TO: ALL TRIUMPH DEALERS - WESTERN ZONE

BULLETIN T-64-41

SUBJECT: TRIUMPH TR-4 WINDOW
WINDER REGULATOR

A-A

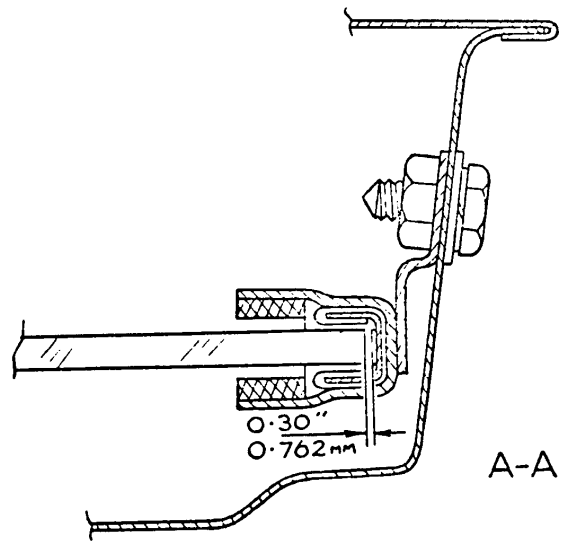
1. Remove trim panel.
2. Raise window and check the clearance of the glass fore and aft in the top of the rear channel. The recommended clearance is .030" which should be maintained for the whole length of the channel. Excess clearance will allow tilting and the jamming of the glass and insufficient clearance will produce stiff operation. Clearance can be obtained by the use of packing washers between the inner door panel and top channel bracket (see illustration A-A).

B-B

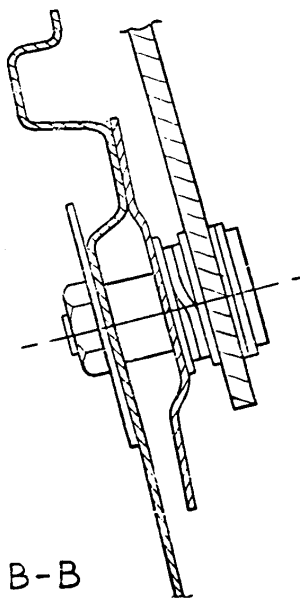
3. Adjust bottom brackets and crimp the tie rod to ensure that the channels are parallel (illustration C).
4. Remove regulator pivot pin nut and delete spring washer under head of nut. Add washer WP0119 1/2"x 7/8" x .050" behind head of pivot bolt and additional washer WP0160 5/16" x 1 5/8" x 16 S.W.G. behind head of nut (illustration B-B).

5. Tighten nut sufficiently to allow ease of operation and peen or center pop end of thread.
6. Refit trim.
